HISTORIC PRESERVATION COMMISSION
Hearing: February 23, 2012, March 8, 2012
& March 22, 2012
Staff Report

CASE NUMBER: HPC12- 65
CITATION ISSUED: No
ADDRESS: 8 W 2ND ST
APPLICANT NAME: Rev. Helen S. Smith
PREPARED BY: Lisa Mroszczyk Murphy
DATE: March 15, 2012

CASE NUMBER: HPC12-100
CITATION ISSUED: No
ADDRESS: 103 W 2ND ST
APPLICANT NAME: Robert Kelley
PREPARED BY: Lisa Mroszczyk Murphy
DATE: March 12, 2012

CASE NUMBER: HPC12-120
CITATION ISSUED: No
ADDRESS: 214-214A East 6th Street
APPLICANT NAME: Lori Duke
PREPARED BY: Christina Martinkosky
DATE: March 14, 2012

East face of the Chimney, showing several spalling bricks (circled) and significant gaps in mortar

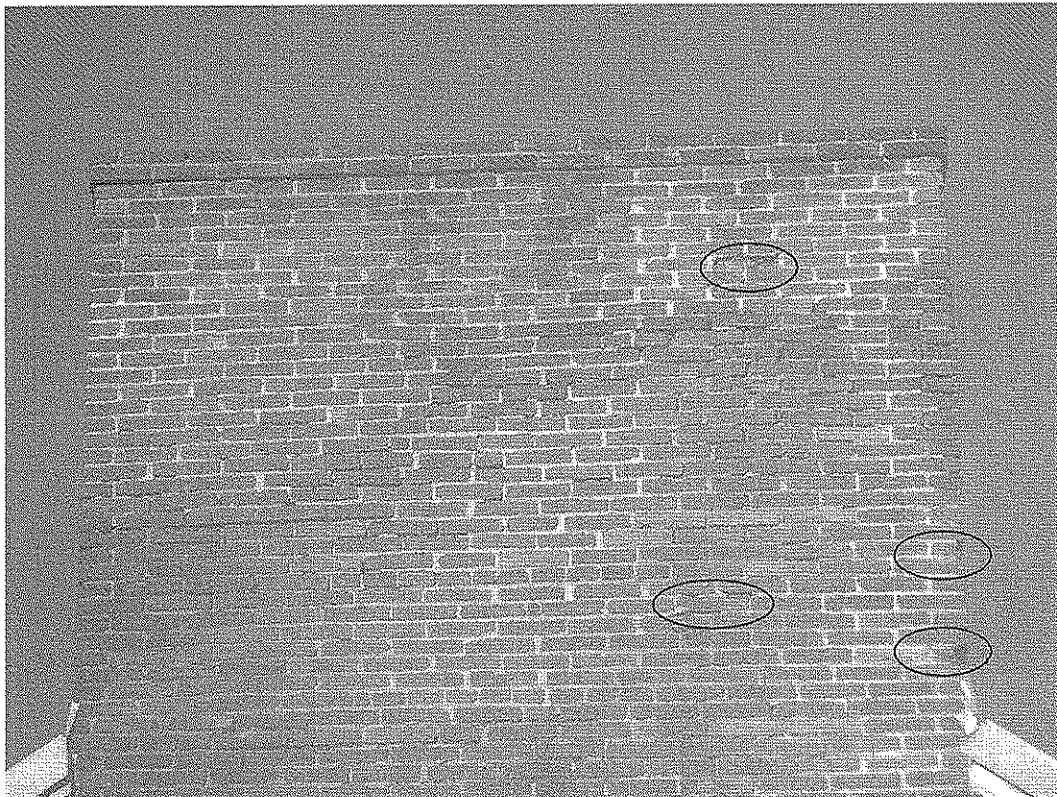
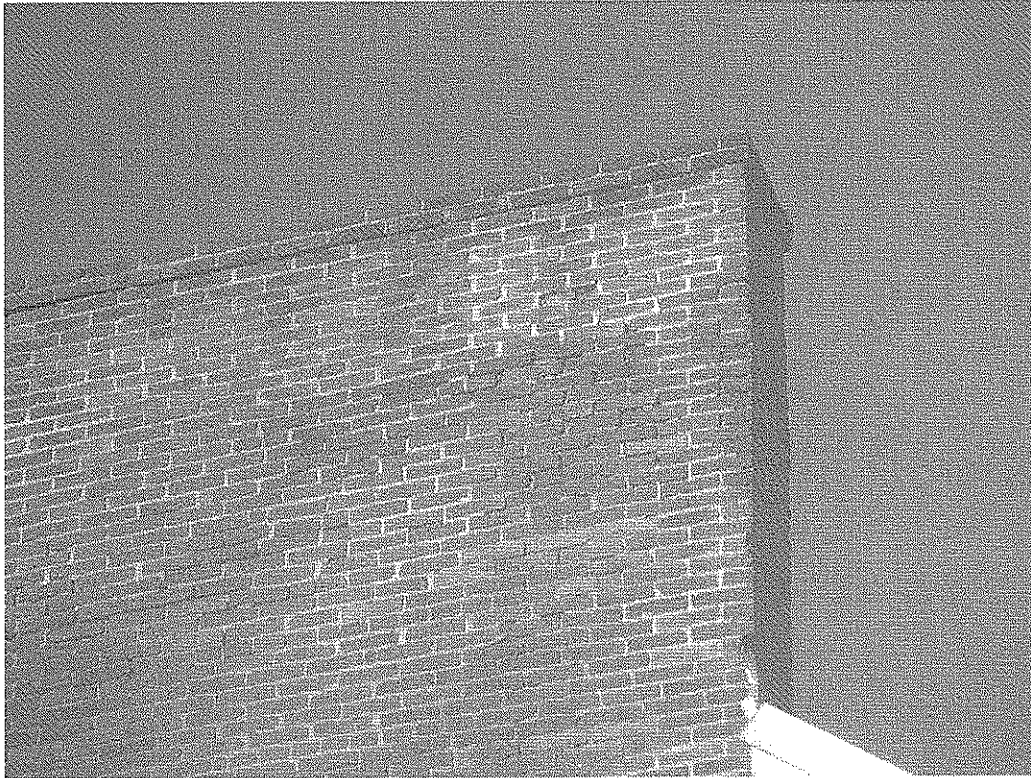
STAFF COMMENTS:

The *Frederick Town Historic District Design Guidelines* state, "The painting or coating of masonry structures that are not currently painted or coated will not be approved, except in those cases where it will help stabilize deteriorating brick" (p. 46).

The building was neglected under previous ownership and the applicant has recently taken appropriate steps to address this by obtaining administrative approval to repoint the east wall with a lime-based mortar and to selectively replace spalled brick in-kind. Significant mortar loss had been permitting water infiltration that led to deterioration, cracking and spalling of the brick. Apart from the bricks that are going to be replaced, the wall is in overall good condition.

Once the approved repair work is completed, the building should be watertight and staff expects deterioration will not progress. It should not be until effectiveness of these repairs can be fully assessed that a water-repellant coating, an irreversible treatment, is considered for this building. Additionally, since chimneys and parapets are more sensitive to freeze-thaw than other areas of a building, they should be regularly assessed to identify weak areas and then maintained regularly to prevent similar situations from occurring in the future.

Staff recommends denial of the application to apply a water repellent coating to the brick because it has not been demonstrated that repointing and the selective replacement of spalled brick is insufficient to make the building watertight.

← ALLEY
VIEW FROM
STREET
ILLUMINATED
AREA IN
BACKGROUND
IS BACK OF
ALLEY and
interior of
house

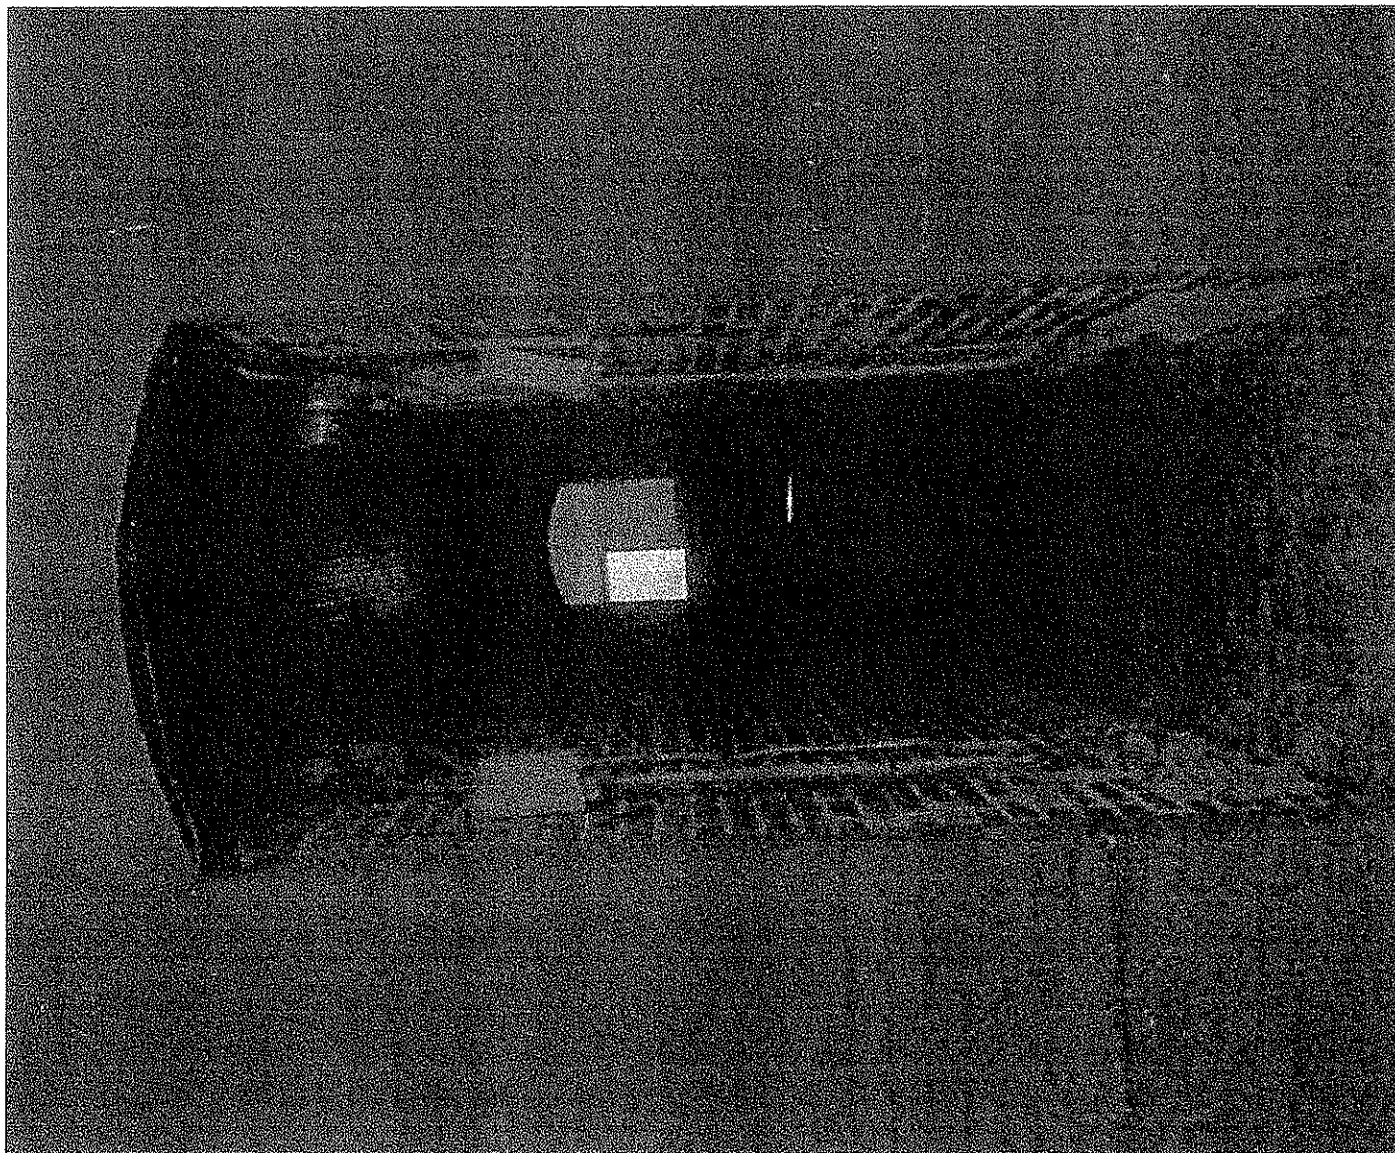
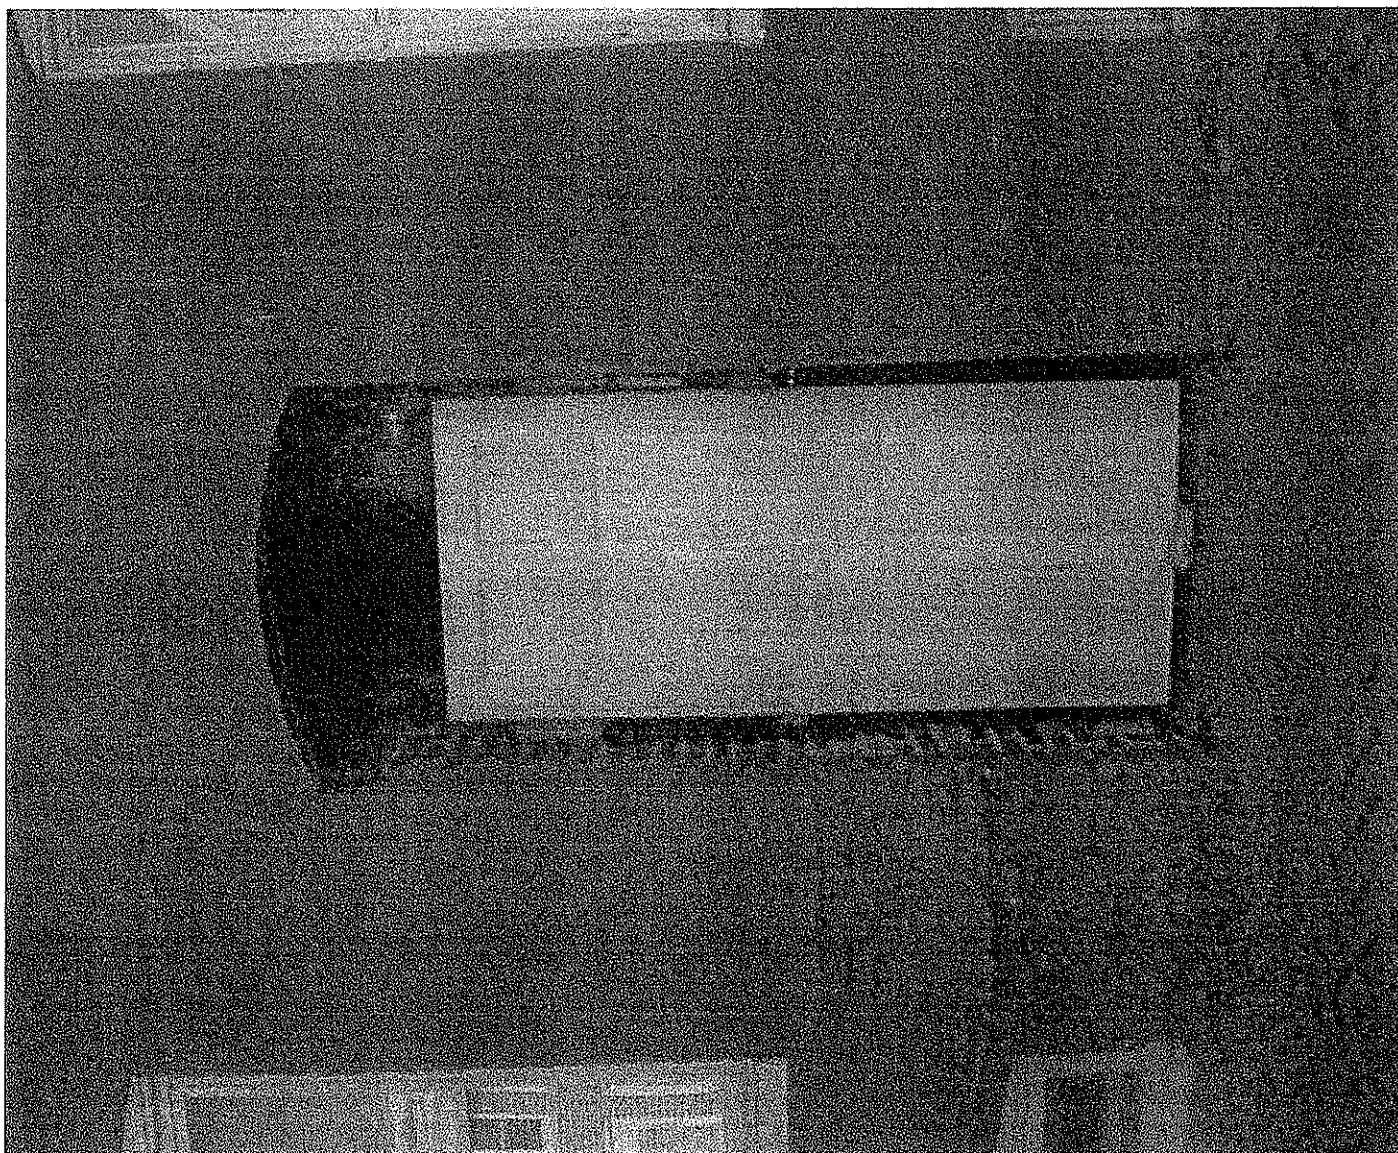
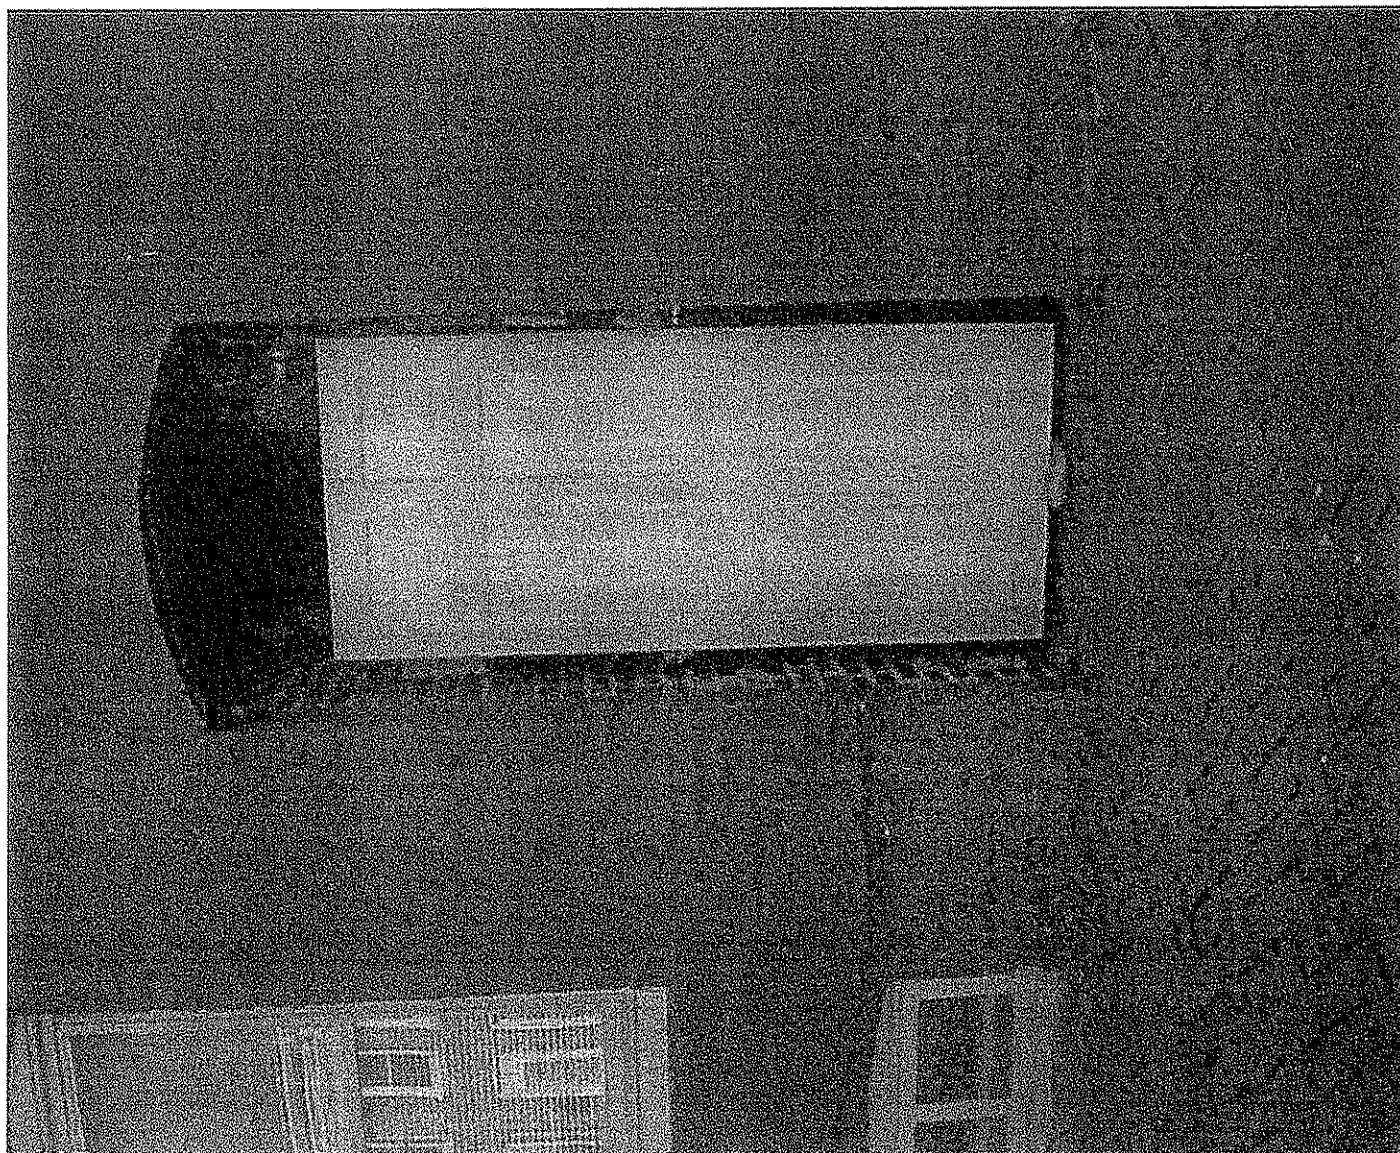
Alley gates in the City of Frederick typically face the street and often lead to a back yard. In this case, the private alley provides access to a semi-enclosed living space. The owner wishes to install a sturdy door for security. Traditionally, alley gates are made of wood or cast iron, may be the height of a typical door, and can incorporate decorative elements above.

There is no physical or documentary evidence that an alley door previously existed at this location. However, alley gates are a common feature found on twin dwellings in Frederick, and its addition is not inappropriate. The *Frederick Town Historic District Design Guidelines* state that "if documentation is not available, a new gate should be based on other historic gates in the neighborhood" (pg. 126).
